# Agenda

## Council Meeting

7.00pm, Tuesday 25 January 2022

<b>Ward:</b>	Melba
<b>Proposal:</b>	Big Housing Build – 147 – 161 Elizabeth Street, Richmond
<b>Existing use:</b>	Currently Vacant, Richmond Public Housing Estate
<b>Applicant:</b>	Homes Victoria
<b>Zoning / Overlays:</b>	General Residential Zone – Schedule 3 Development Plan Overlay – Schedule 10 Development Contributions Plan Overlay – Schedule 1
<b>Date of Application:</b>	N/A
<b>Application Number:</b>	N/A

Image: Site Plan showing Building 1 and Building 2  
Source: Documentation provided by Homes Victoria

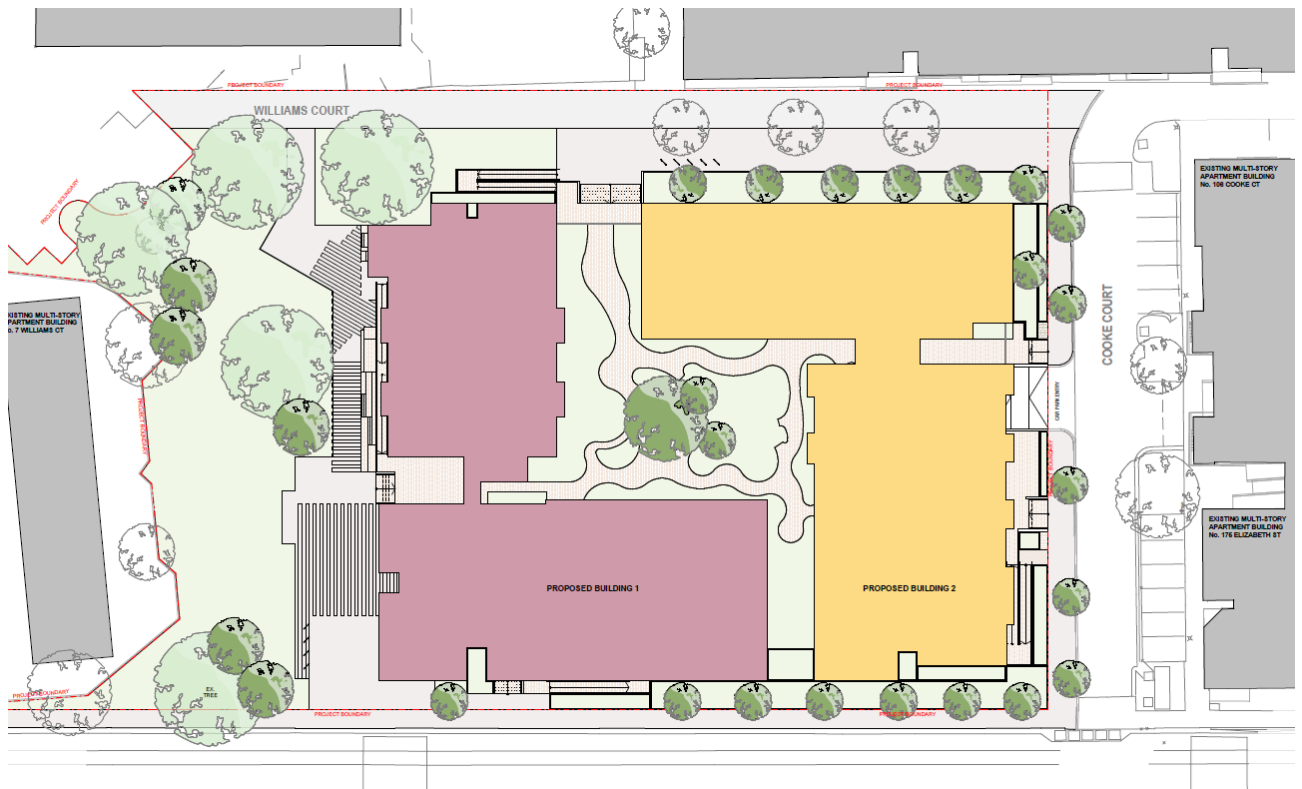
34. Building 1 within the eastern section of the allotment comprises two building sections, being 7 storey to Elizabeth Street reducing to 5 storey to the north. The two building sections are connected by a walkway. Building 1 will accommodate social housing.
35. Building 2 within the western section of the allotment also comprises two building sections, being 8 storey to Elizabeth Street reducing to 4 storey to the north. The two building sections are also connected by a walkway. Building 2 will accommodate affordable housing.
36. The plan below outlines the layout of the two buildings.

37. The application proposes a single basement level accessed from Lewis Court (incorrectly labelled on the plans as Cooke Court). 76 car parking spaces including 8 DDA compliant spaces are located within the basement. A range of service cupboards/rooms and the rainwater tank are also located in basement, along with a 97sqm void area providing opportunity for deep soil planting.

Image: Ground floor plan

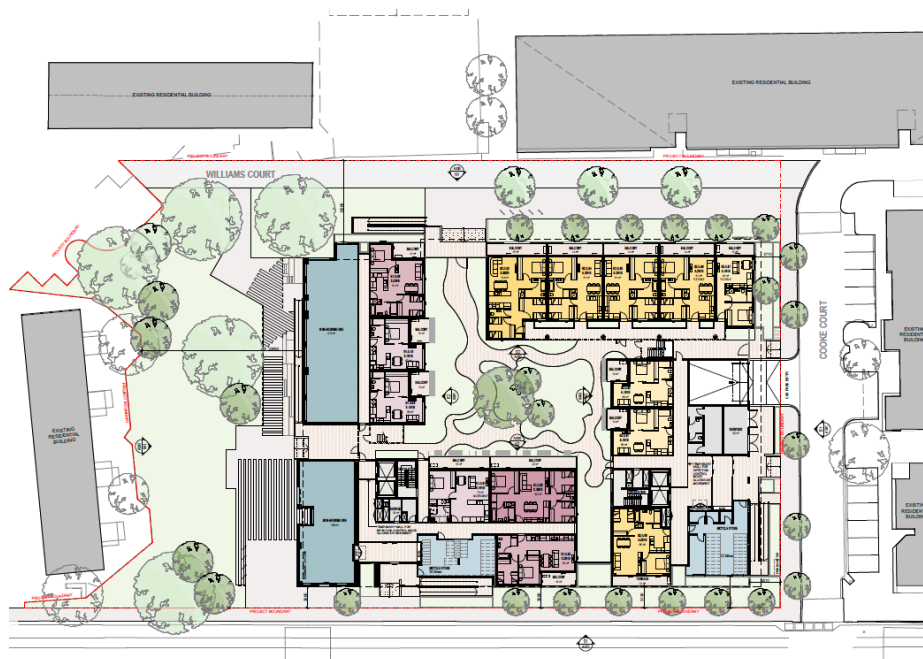
300. In regards to visual bulk impacts, the most sensitive interface are the dwellings directly to the east and north. It is considered that within this built form context, with the site and overall Richmond Housing Estate forming part of a strategic redevelopment site, views from windows and open space areas to built form is not an unreasonable expectation.

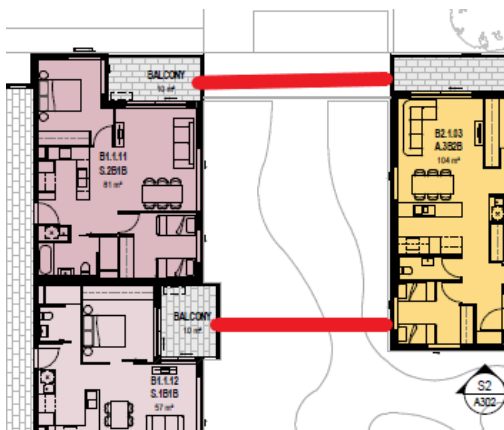
363. In relation to internal overlooking, there are concerns with the interface between the following dwellings, it is noted as there are no dimensions on the plans, these are best guess estimates:

- (a) Apartments Building 1 – G.09, G.10, 1.11, 1.12, 2.11, 2.12, 3.11 and 3.12;

364. Conditions should require the above interfaces to achieve compliance with clause 52.20-6.13 overlooking.
365. A further condition should also require all screening between balconies to be identified as achieving a minimum height of 1.7 metres and being obscure glazed or of a solid material.
366. Whilst there are some concerns with overlooking from upper level apartment balconies into lower level apartment balconies it is noted that the requirements of clause 52.20 specifically exempt the proposal from meeting all requirements of Clause 58, including the internal views provision, and as such an assessment against this provision cannot be undertaken. Each lower level apartment will still maintain a reasonable amount of open space that would not be visible from the apartments above.

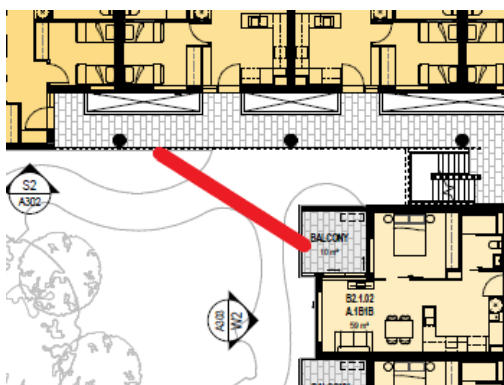
- (b) Apartments Building 2 – G.02, 1.02, 2.02 and 3.02;

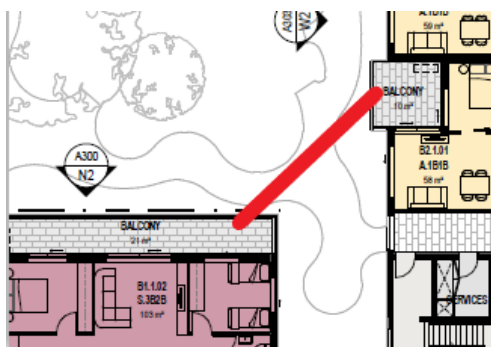
- (c) Apartments Building 1 – G.02, 1.02, 2.02, 3.02, 4.02, 5.02 and 6.02;

- (d) Apartments Building 1 – G.01, 1.01, 2.01, 3.01, 4.01, 5.01 and 6.01; and

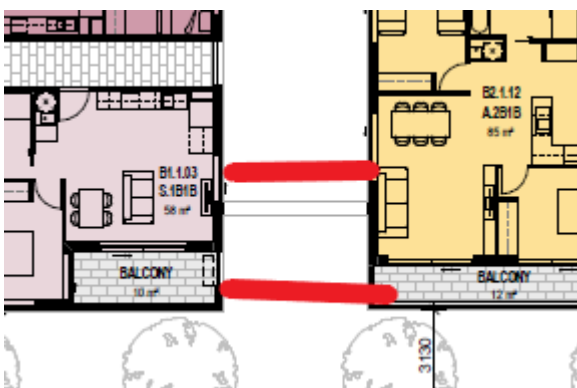
(e) Apartments Building 1 – G.03, 1.03, 2.03, 3.03, 4.03, 5.03 and 6.03.

### Vehicle Crossing – Cross Section

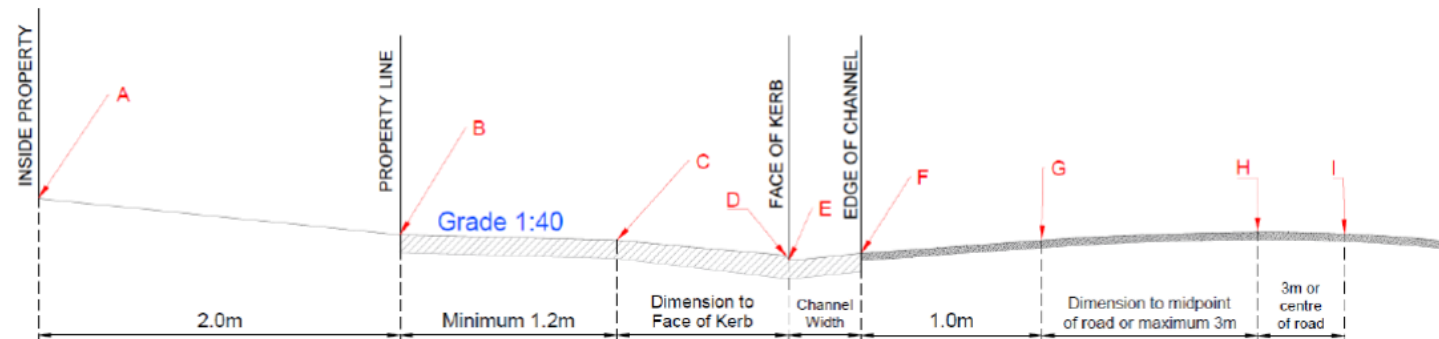
Left: No footpath has been provided on the west side of Lewis Court. As Lewis Court is a private road, the applicant is to confirm footpath construction and arrangements to be made with the owner/manager of the road.

The designer is to submit a 1:20 scale cross section for each proposed vehicle crossing showing the following items:
